City of Gig Harbor Design Review Board Virtual Meeting of October 13, 2022 at 5:00 pm

STAFF REPORT

Re: 3555 Erickson Development (PL-DR-22-0047)
Public Meeting Date: October 13, 2022

DRAWING NO.:
SKAO.1

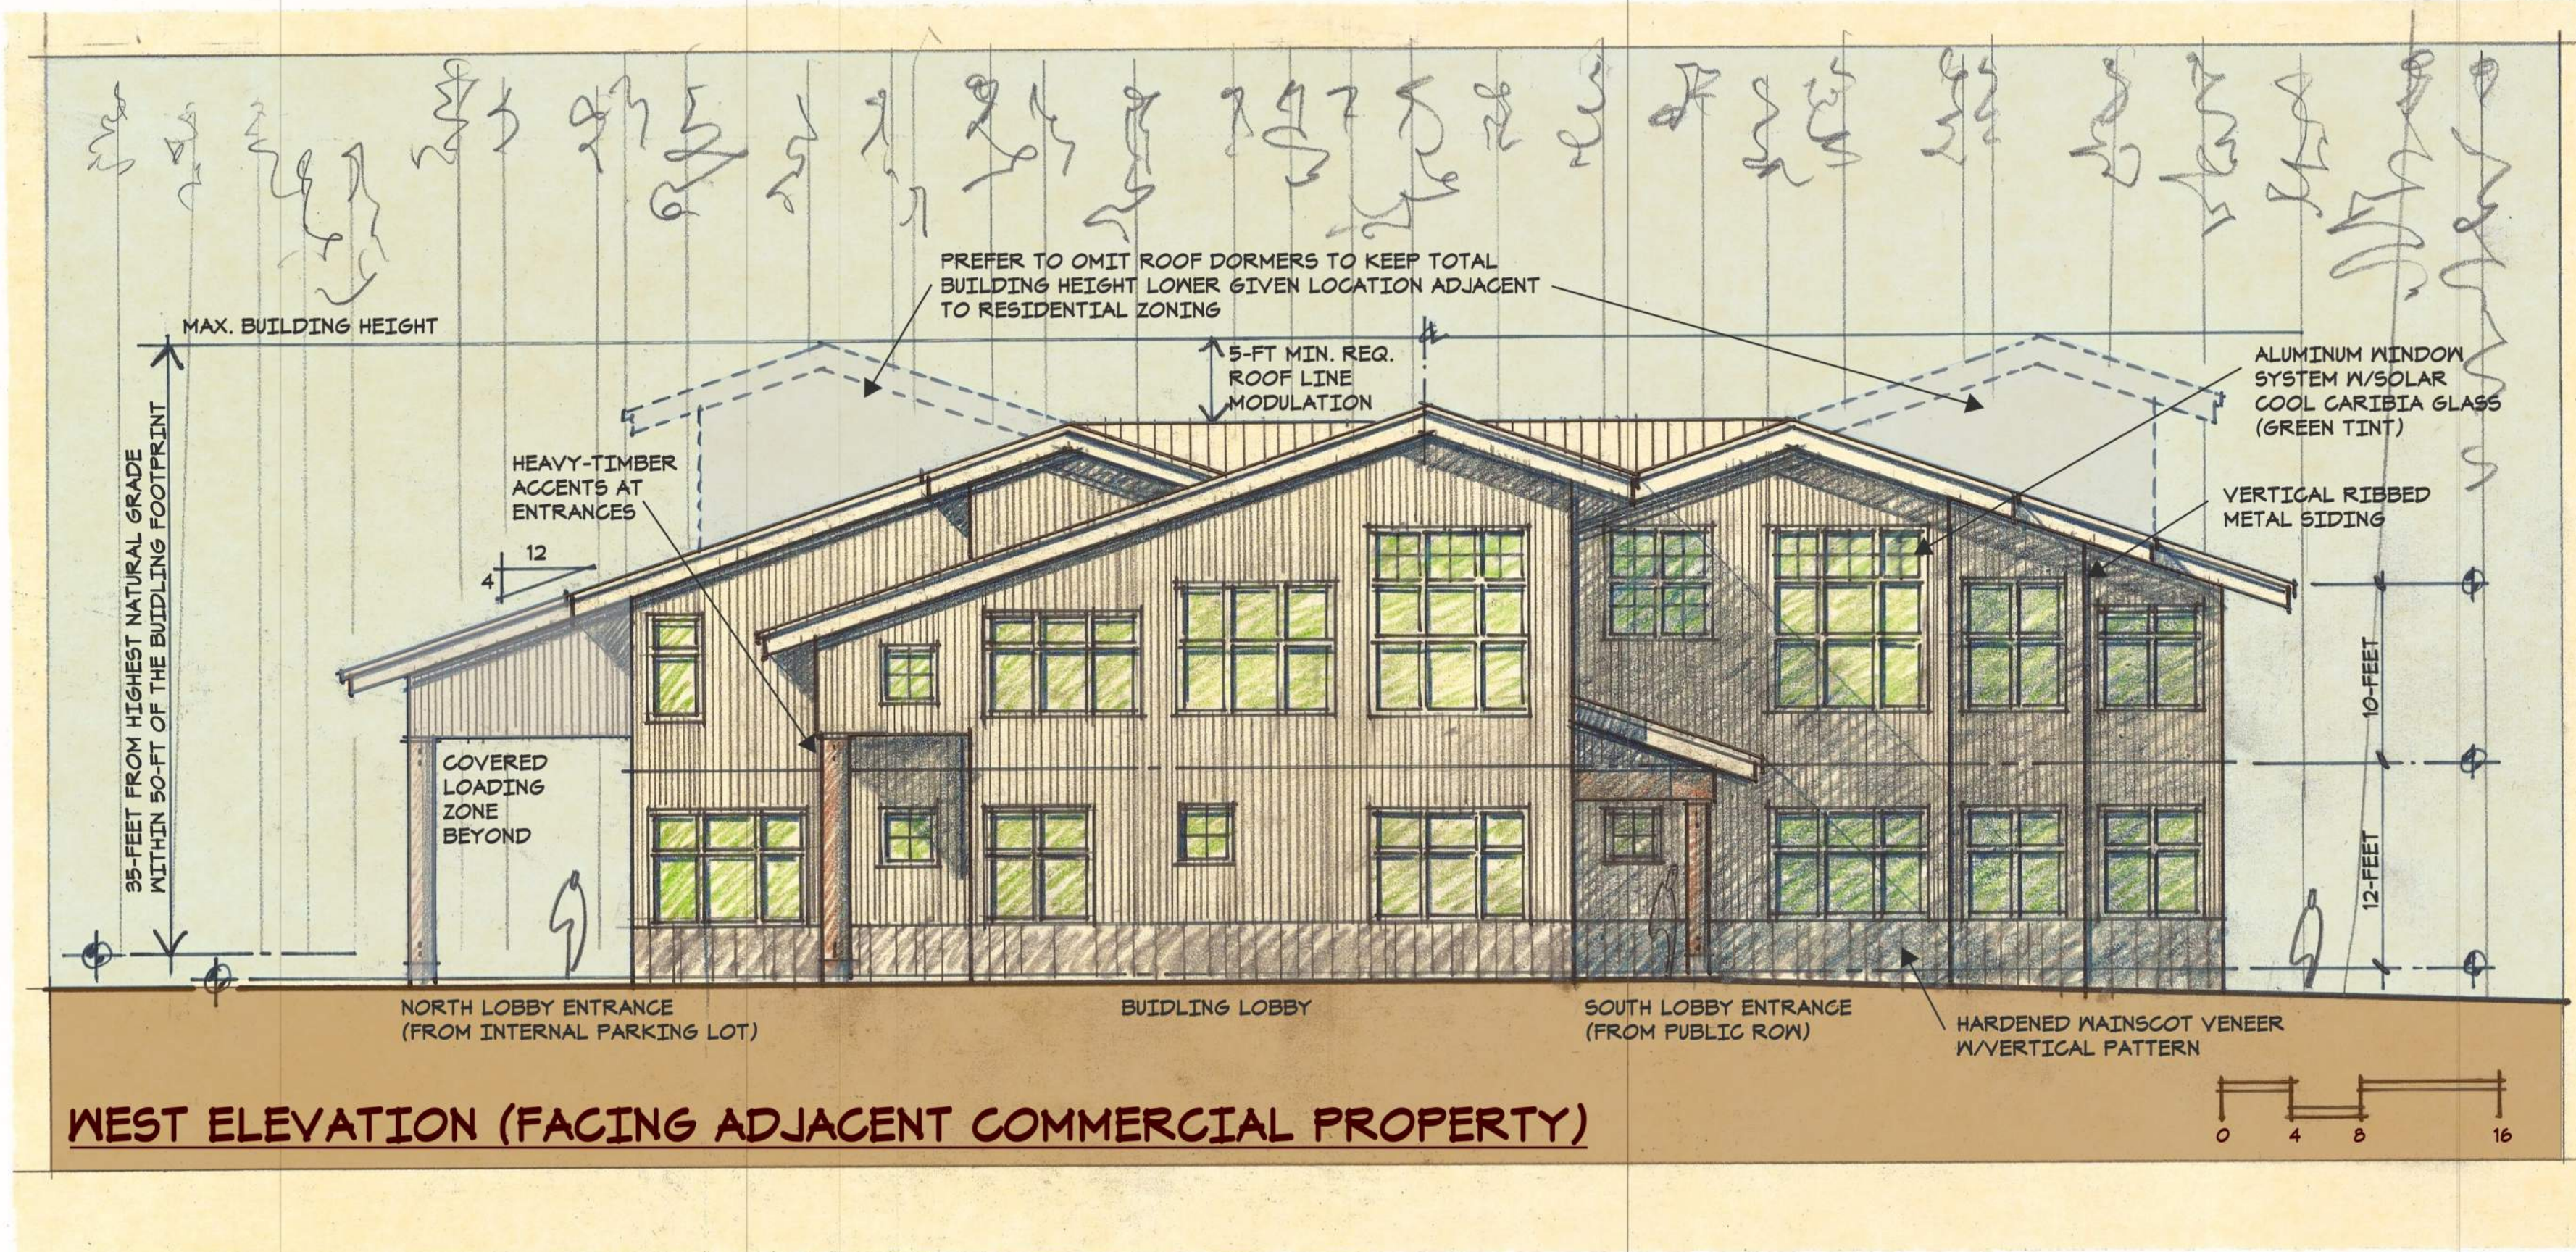
- i. 17.99.190(A) **Limit building footprint to the average size of building footprints in the opposing zones**
 1. Applicant has submitted calculations indicating the average building footprint of the surrounding buildings is 21,842 square feet. It should be noted that this calculation incorrectly includes the square footage of the Hangar Clinic, which is not located in an opposing zone district. The correct average is 24,735 square feet.

DRAWING CONTENTS:
WEST + SOUTH BUILDING ELEVATION STUDIES
SKA4.1

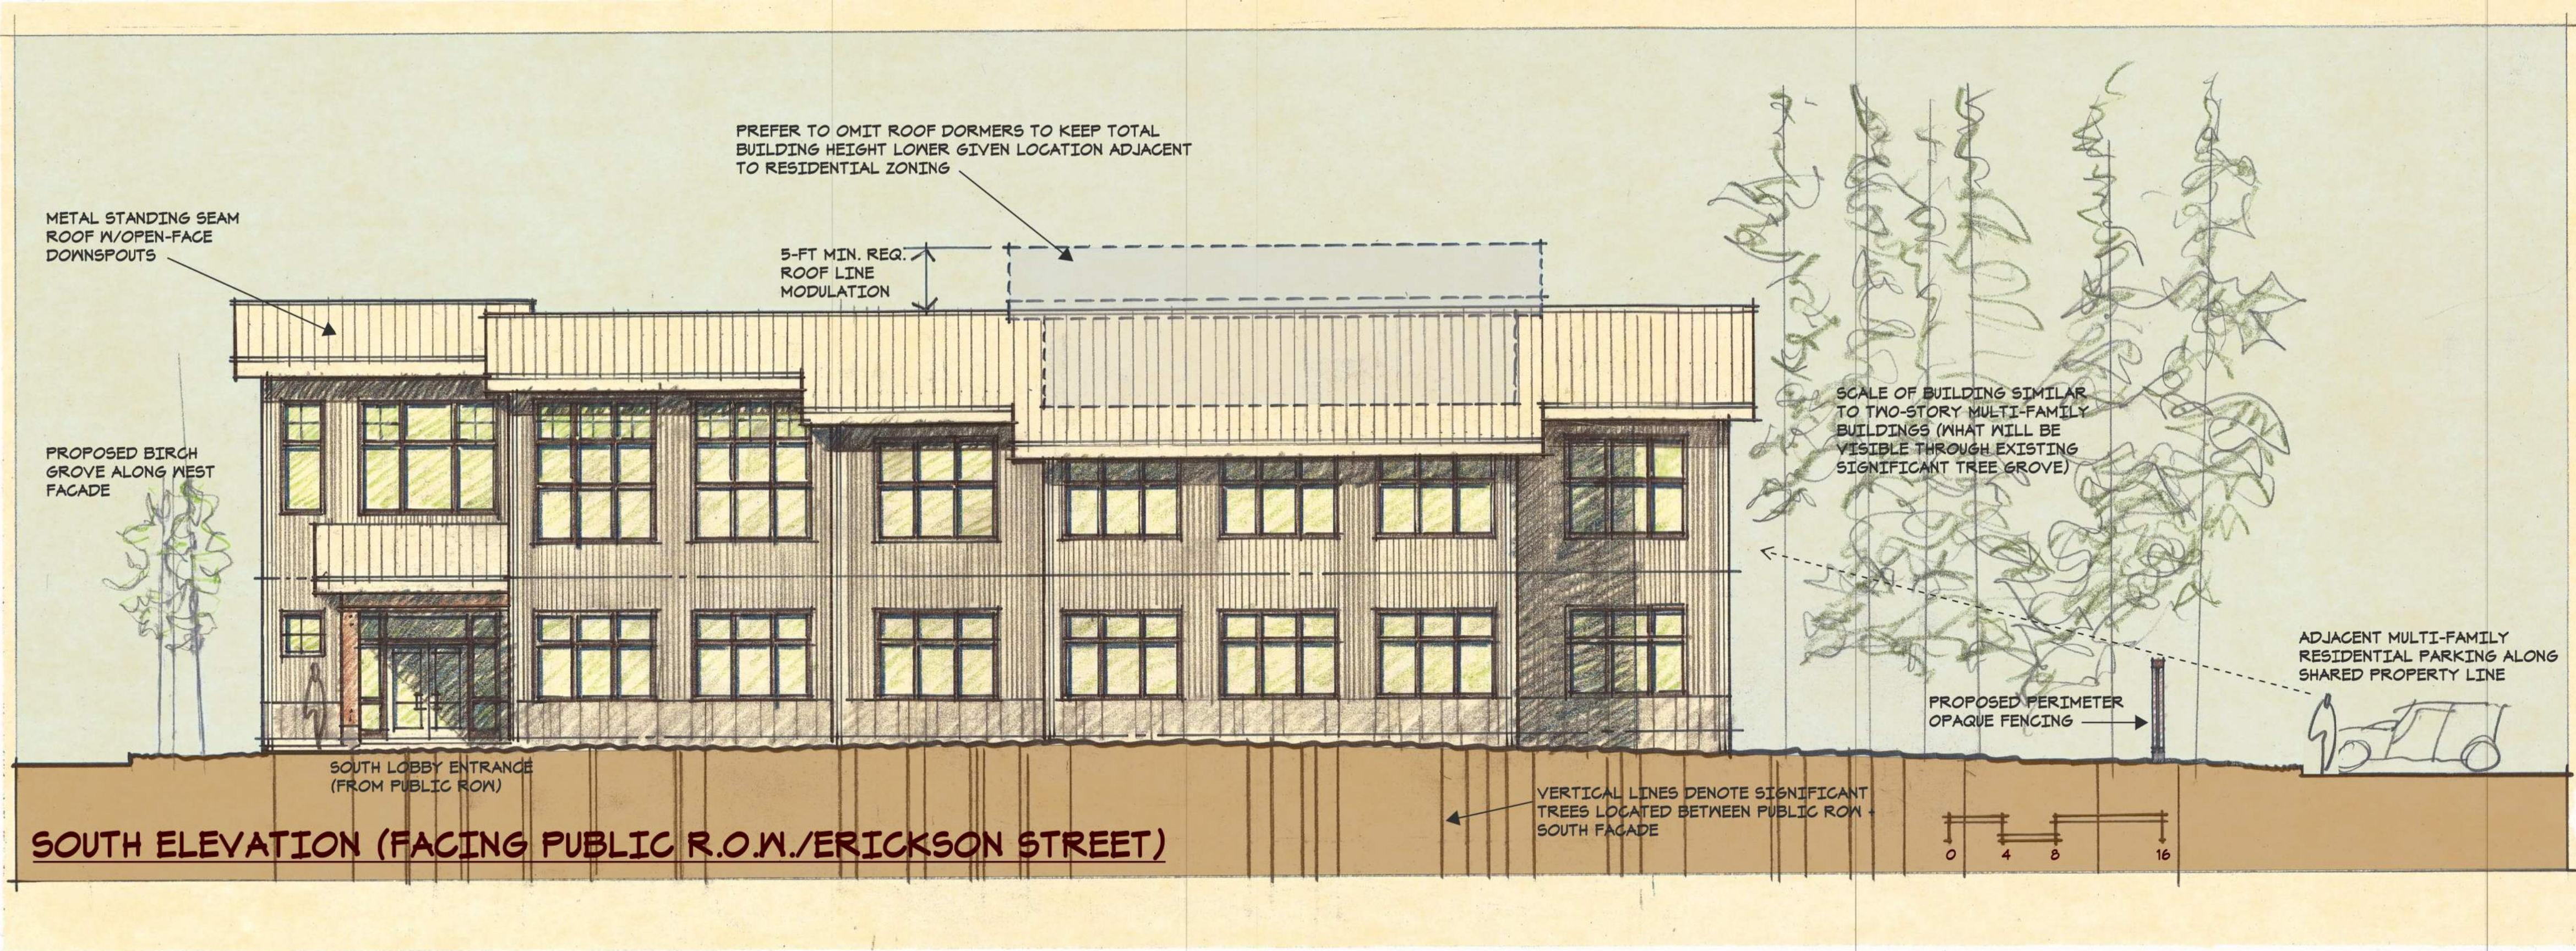
- iii. 17.99.190(C): **Avoid facing dissimilar structures along streets.**
 1. The windows, doors and massing depicted on submitted elevations do not look particularly residential

in design, however dense vegetation is proposed along the street front, largely screening the structure from the street.
